DRAFT
FIFTH EXPLANATION OF SIGNIFICANT DIFFERENCES (ESD)
FOR THE
NEW BEDFORD HARBOR SUPERFUND SITE
UPPER AND LOWER HARBOR OPERABLE UNIT 1 (OU1)
NEW BEDFORD, MASSACHUSETTS
APRIL 2015

EPA REGION 1

New Bedford Harbor Superfund Site (Site)
Upper and Lower Harbor Operable Unit 1 (OU1)
Bristol County, Massachusetts

Figure 21a - Conceptual locations of upper harbor CDFs A, B and C
 New Bedford Harbor Superfund Site, ROD 2

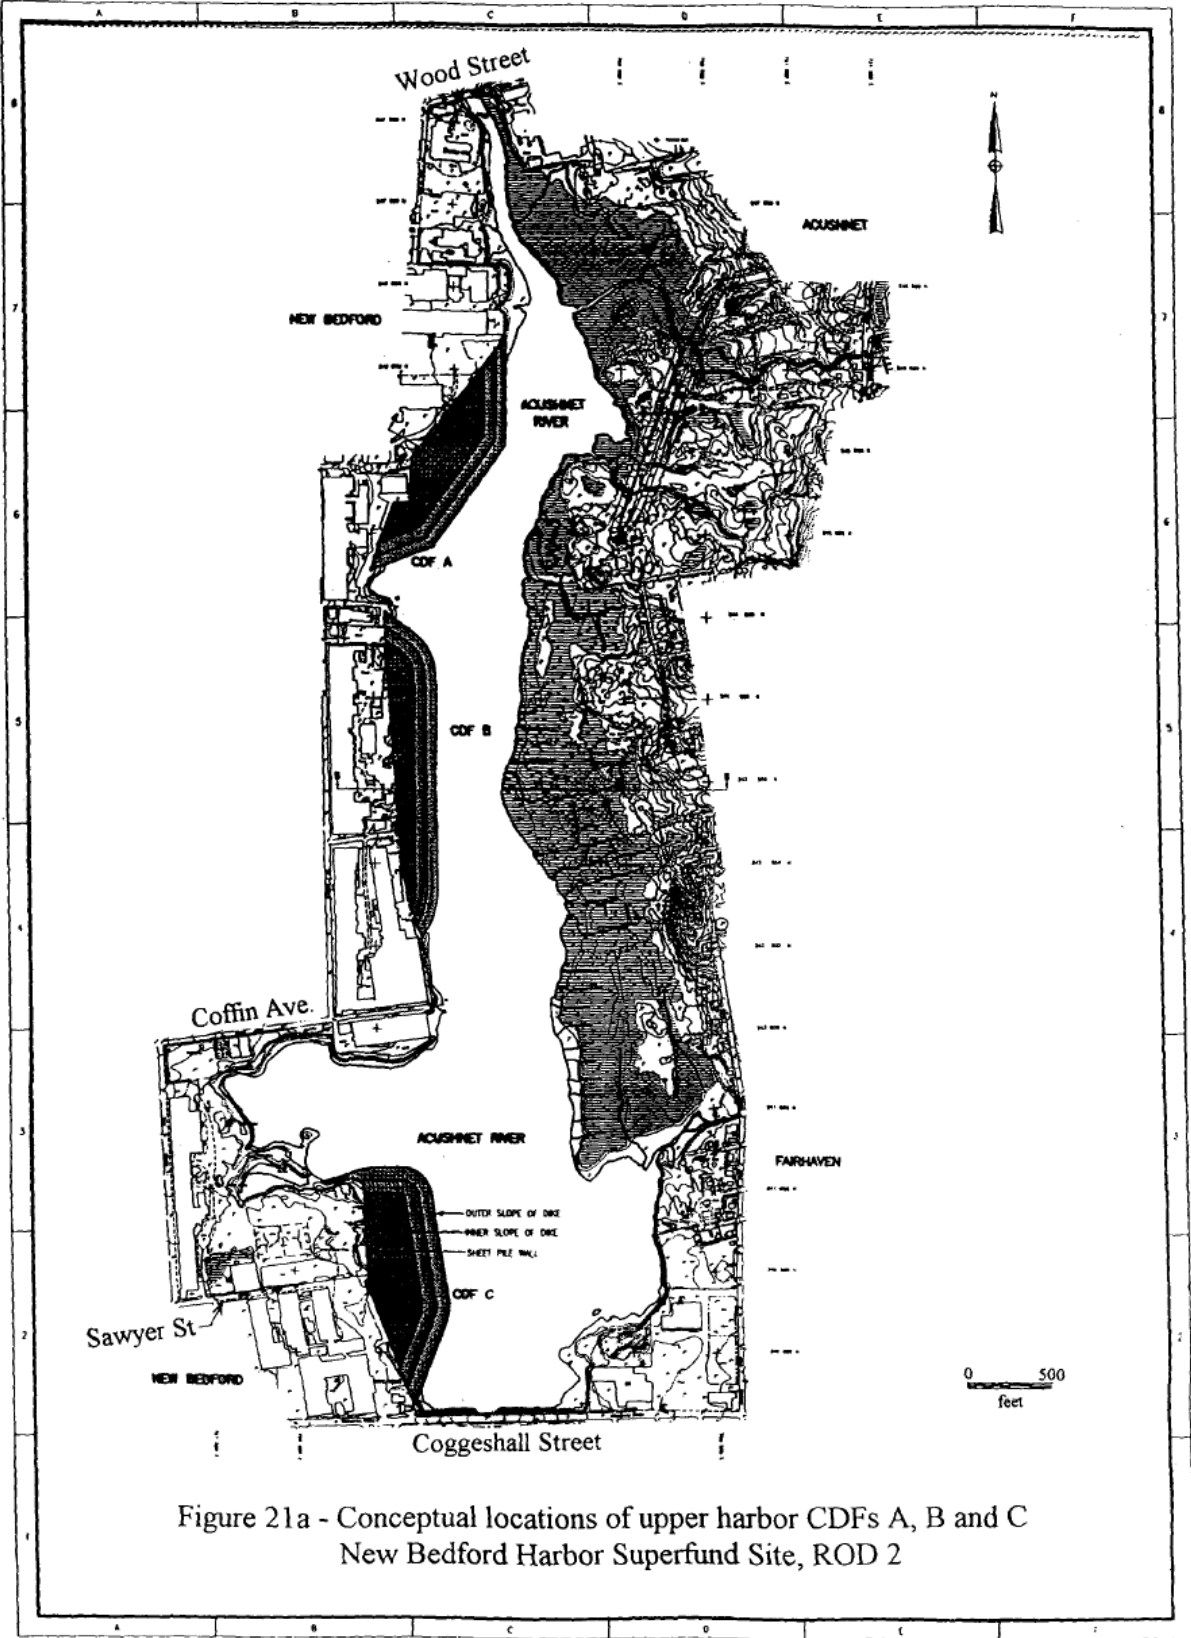
Through this draft fifth ESD to the OU1 ROD, EPA is proposing to modify the remedy for the Upper and Lower Harbor by eliminating the construction of the planned CDFs A, B and modified-C and selecting off-site disposal for the sediment slated for disposal in those planned confined disposal facilities. As conceptually planned under the OU1 ROD, CDFs A, B and C were to be shoreline structures (see attached Figure 21a from the OU1 ROD). Note that CDF C was planned for construction at and around the location of the pilot study CDF (see discussion in Section II.A, below, regarding the creation and use of the pilot study CDF). As such, the Pilot CDF is located within the footprint of the conceptual location of CDF C.

Considering the potential effectiveness and implementability concerns associated with CDFs, the longer timeframe needed for CDF construction and utilization, and the higher estimated cost of CDF disposal as compared to off-site disposal, EPA proposes, through this draft ESD, to eliminate CDFs A, B and modified-C as a disposal element of the OU1 remedy and instead select off-site disposal for the approximately 175,000 cubic yards on *in situ* contaminated sediment currently slated to be disposed of in CDFs A, B and modified-C.

Figure 2-1 Confined Disposal Facility

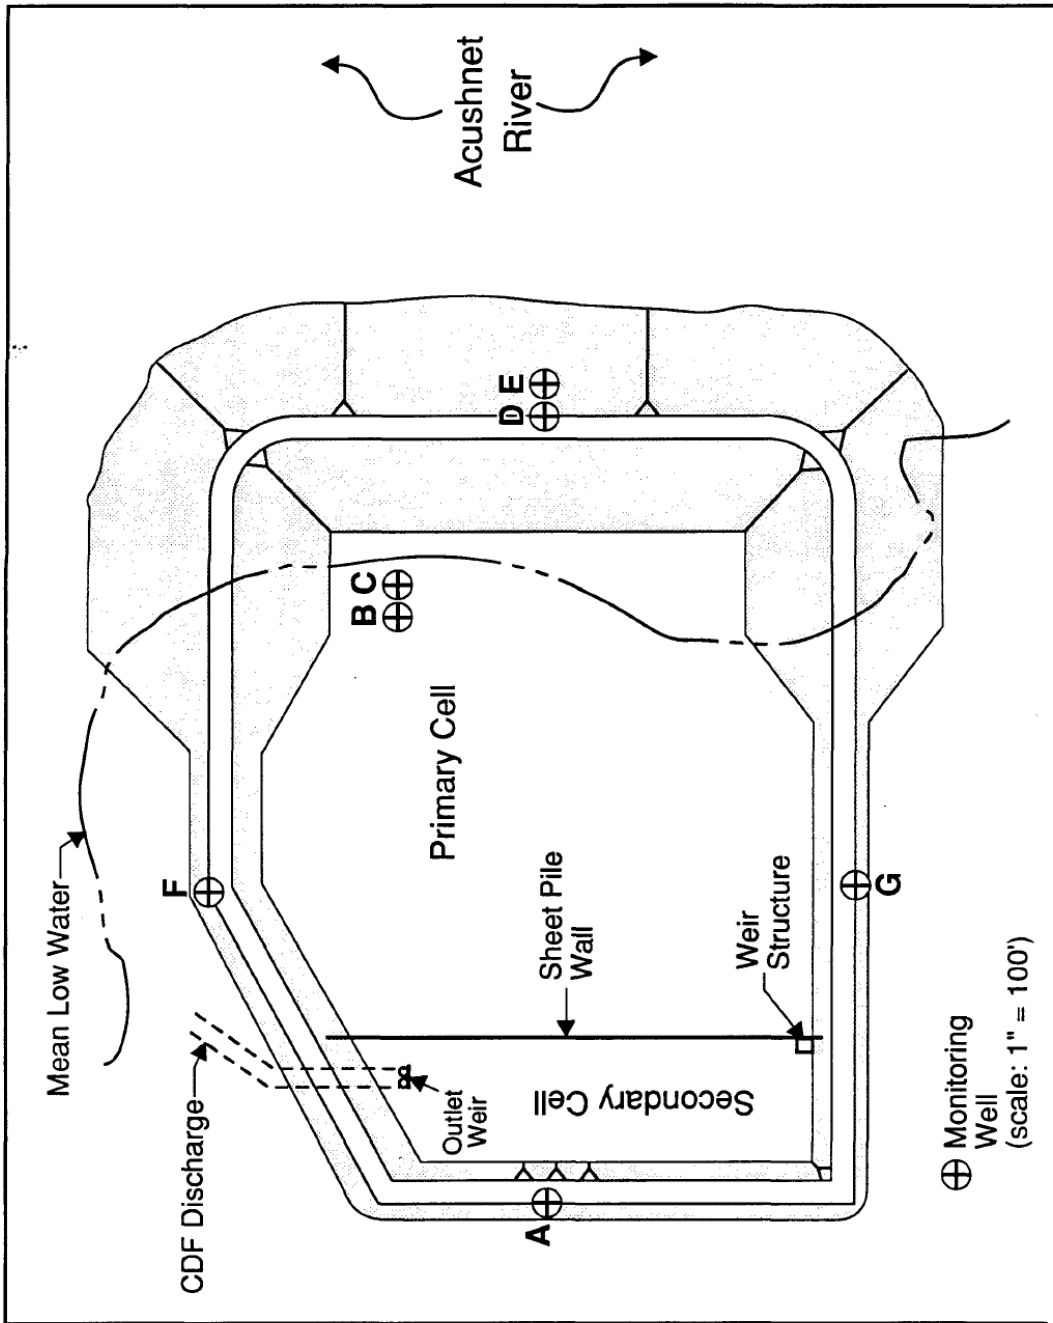
Groundwater and air monitoring performed at the Pilot CDF since 1992, along with groundwater modeling, demonstrate that PCBs are not migrating from the Pilot CDF area. See attached Figure 1 from the Sawyer Street Semi-annual Groundwater Monitoring Technical Memorandum showing location of groundwater monitoring wells. As noted in ESD1, underlying the Pilot CDF is a clay layer sandwiched between the Pilot CDF contents and the underlying sands. The clay layer acts as a naturally impermeable barrier to the movement of contaminants from the area. The constructed dike serves as three sidewalls of the Pilot CDF. Due to the type and quantity of materials used to construct the dike, these sidewalls have moderate permeability with an estimated hydraulic conductivity of 3 ft/day. Although these sidewalls are not impermeable, the over 20 years of groundwater monitoring data demonstrate that PCBs are not migrating. The sheet pile wall that serves as the sidewall separating the Pilot CDF from Cell #1 is impermeable. Consistent with the process described in ESD1, since the monitoring and modeling performed to date of the Pilot CDF confirm that PCBs are not migrating from the area and given the subsurface and sidewall features, EPA intends to make the Pilot CDF an element of the final remedy.
